From: Dick Lange, P.E., Building Inspector/Plan Reviewer *D.L.*
To: Jim Breuckman, Planning Department
Date: February 4, 2014
Re: Campus Corners Retail Review #3, 15-15-101-024 City File #13-012

The site plan review for Campus Corners Retail Review #3, 15-15-101-024 City File #13-012 was based on the following drawings and information submitted:

Sheet # SP.101, A.101, Elevation Sheet

From: Jason Boughton JB
To: Jim Breuckman
Date: February 4, 2014
Re: Campus Corner Retail, City File #13-012, Section #15
Site Plan Review #3

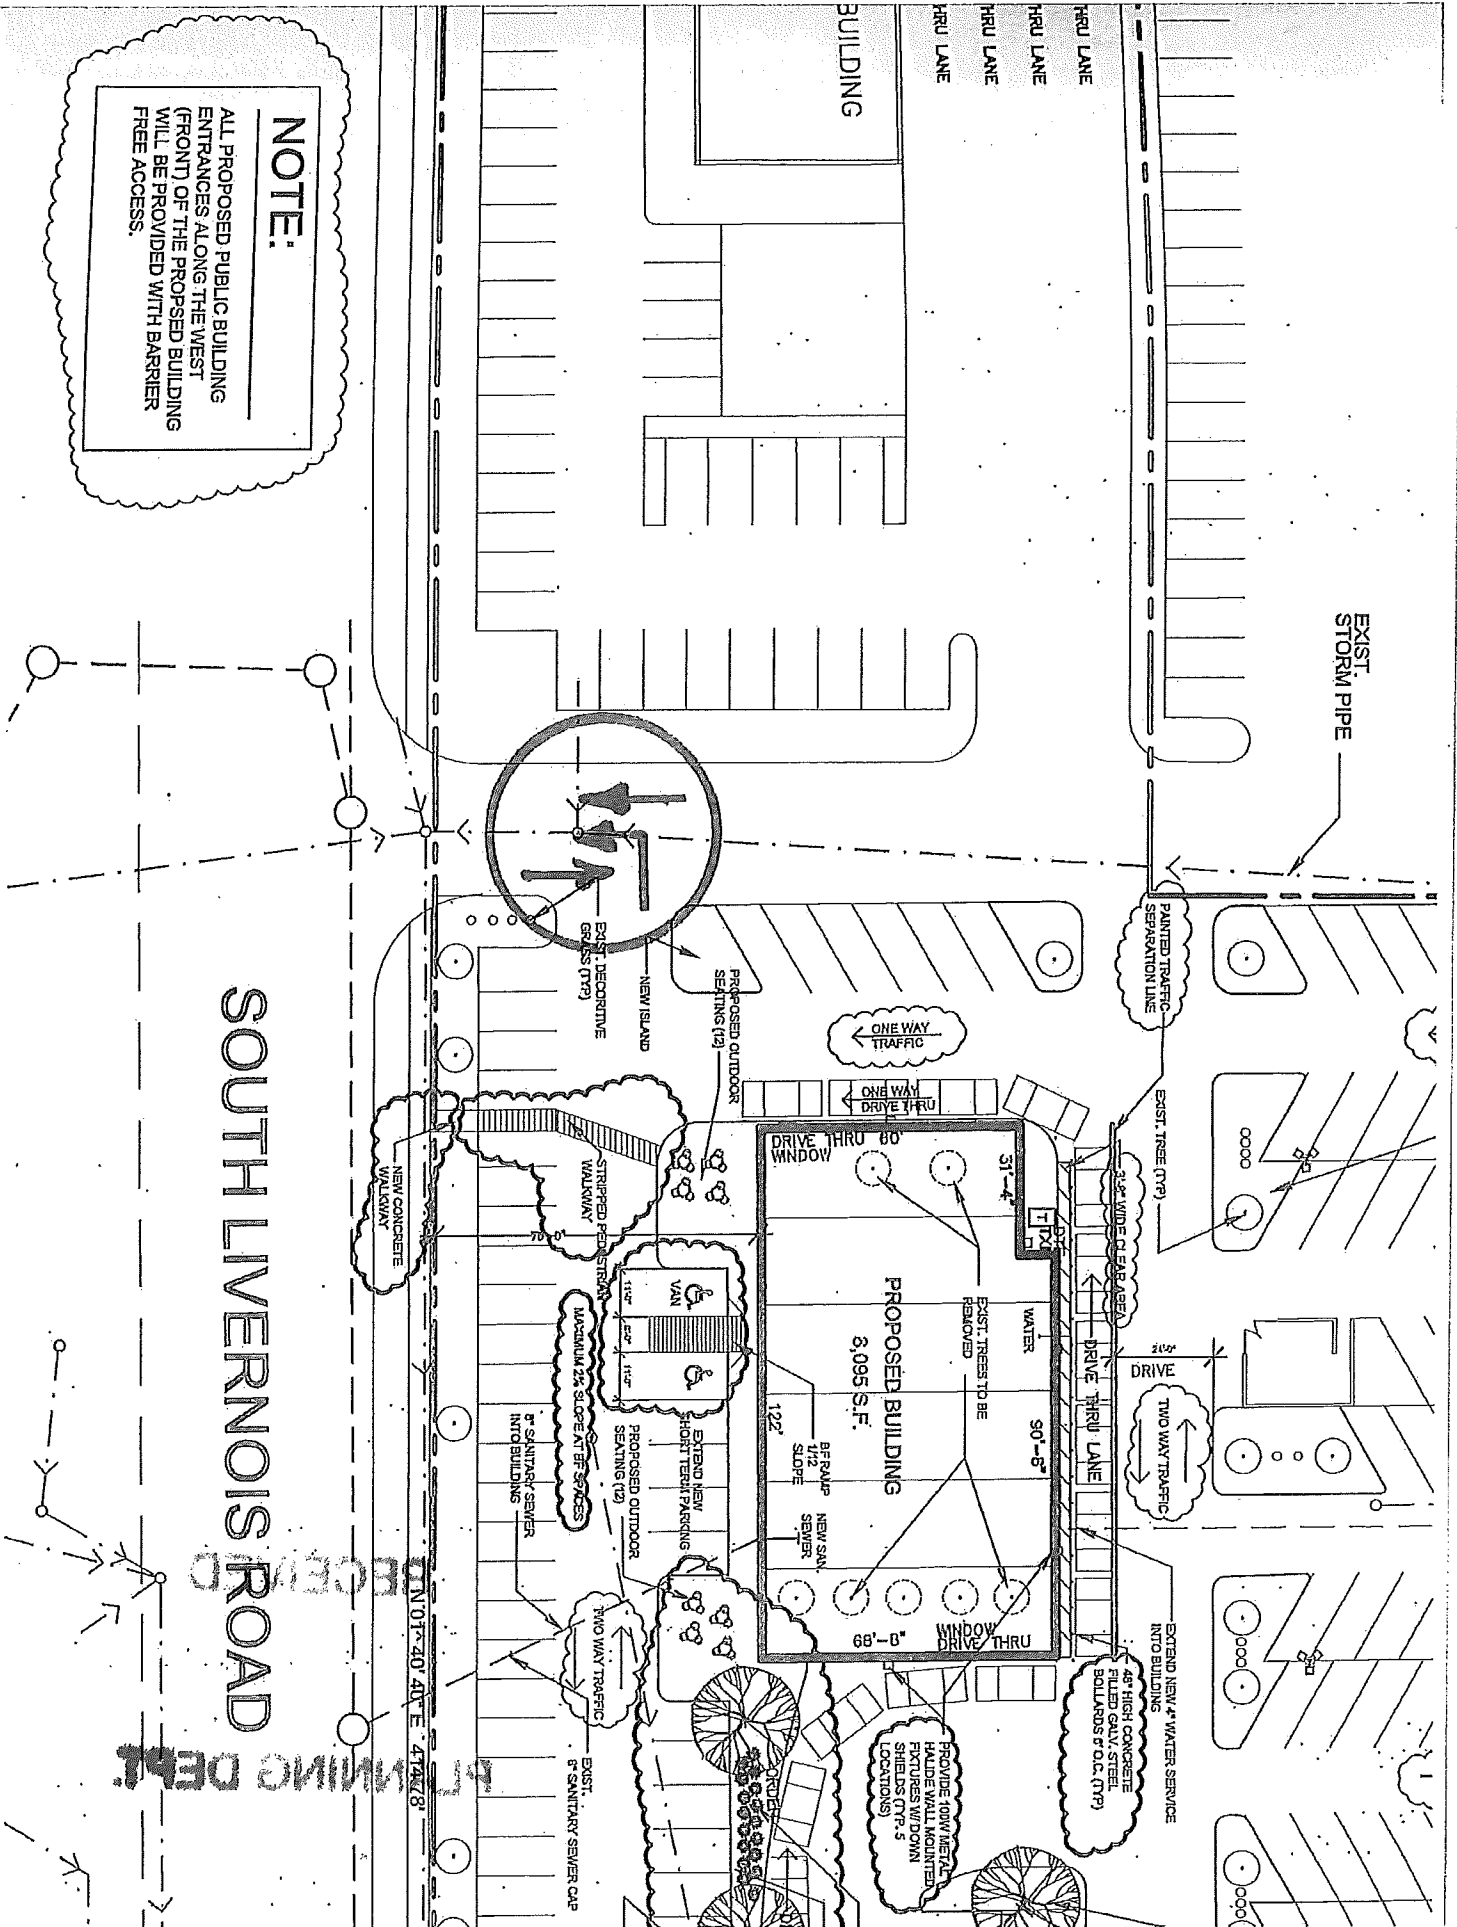
1. Accessible parking including parking and access aisle surface slope details-
 - a. Indicate the proposed surfaces slopes of accessible parking spaces and their access aisles. Provide sufficient point elevations on the plan at the perimeter of such spaces to clearly verify the provisions of ICC/ANSI A117.1-2003, Section 502.5 have been satisfied (1:48 max slope).

- b. Provide details of required accessible parking signage per the requirements of ICC/ANSI A117.1-2003, Section 502.7. Signs identifying van parking spaces shall contain the designation "van accessible."

2. The proposed curb ramp at the accessible parking does not appear to comply with ICC/ANSI A117.1 – 2003, Section 406. Curb ramps require a minimum 36" landing at the top. See Figure 406.3. I would suggest relocating the curb ramp directly adjacent to the north side of the van accessible parking space.

3. Exterior accessible route including slope details-
 - a. Indicate on the Site Plan the following proposed accessible route/routes to the accessible entrances as applicable.

- i. 1104.1 Site arrival points. Accessible routes within the site shall be provided from public transportation stops, accessible parking and accessible passenger loading zones and public streets or sidewalks to the accessible building entrance served.

- ii. The proposed route from the public sidewalk to the building does not appear to have a required curb ramp at the exterior outdoor seating area. I would suggest relocating this route to align with the accessible parking curb ramp.
- b. Provide sufficient grade information on the plans along the proposed accessible route/routes to verify compliance with the requirements of ICC/ANSI A117.1-2003, Section 402.
- c. Provide details (as applicable) of the following components along the proposed accessible route/routes to verify compliance with ICC/ANSI A117.1-2003:
 - i. Door maneuvering clearance and ground surface slope per Section 404.
 - ii. Ramps per Section 405.
 - iii. Curb Ramps per Section 406.
- 4. Provide sufficient grade information on the plan to verify compliance with Section 1804.3 for site grading away from the building (2% minimum).
